WINDSHIELD WIPER IMPROVEMENT

Models Affected: 2007-10 Model Year Vision Buses with Single Wiper Motor System

S U 1 1 0 1

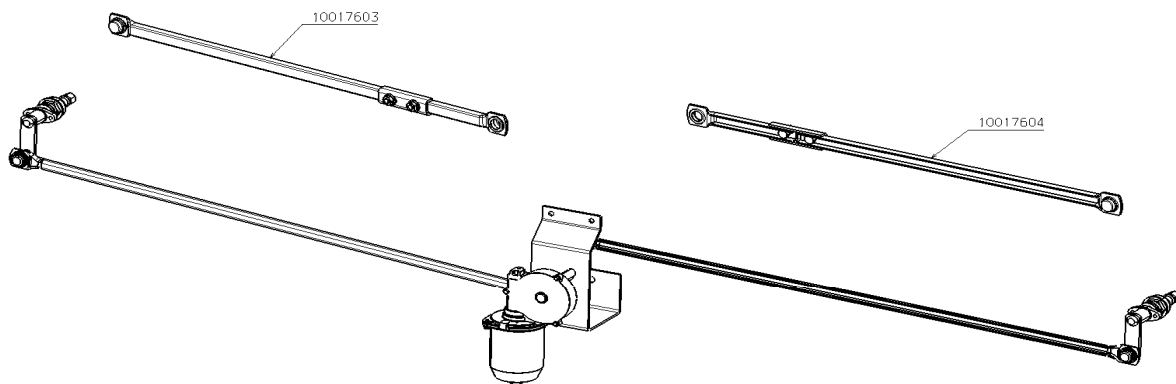
Due to variations in the location of the windshield wiper motor between the pivot points, it may be necessary to replace one of the links of the windshield wiper linkage on the side that requires adjustment with the appropriate Blue Bird service part listed below.

Wiper system improvement can be achieved without changing both links.

10017603 LINK ASSY,WIPER,24.75,16MM,BALL DRIVE,ADJ,LH (Driver's Side)

10017604 LINK ASSY,WIPER,24.75,16MM,BALL DRIVE,ADJ,RH (Curb Side)
